## Notice 04-001

### Reduced Pressure Principle Assemblies

Model 825YA  $\frac{3}{4}$ ", 1", 1-1/2", 2"

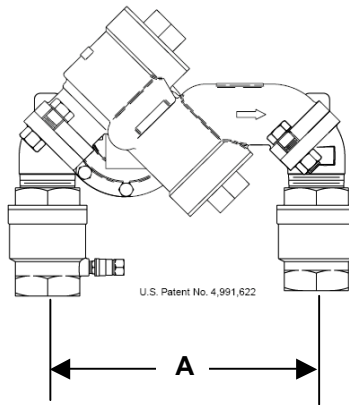
It has come to the attention of the Foundation that some of the following FEBCO assemblies have been sold with a dimensional variation between the centerlines of the vertical inlet and vertical outlet. The assemblies affected include the following:

This variation in "A" has been found to be up to 1/8" for the  $\frac{3}{4}$ "-1" sizes, and 1/4" for the 1-1/2"-2" sizes. The variation in centerline dimension has not been found to affect the overall performance of the assembly, however, it has been reported as a significant problem when a change-out of the body occurs in the field. If the inlet and outlet piping is fixed, a body being replaced with a different end-to-end centerline dimension will not fit.

The subject assemblies affected with the longer centerline dimension have a serial number beginning with the letter "H" (i.e., Serial #Hxxxxx).

Should you have an assembly affected by this situation, please contact FEBCO at (559) 252-0791 for Foundation Approved replacement components.
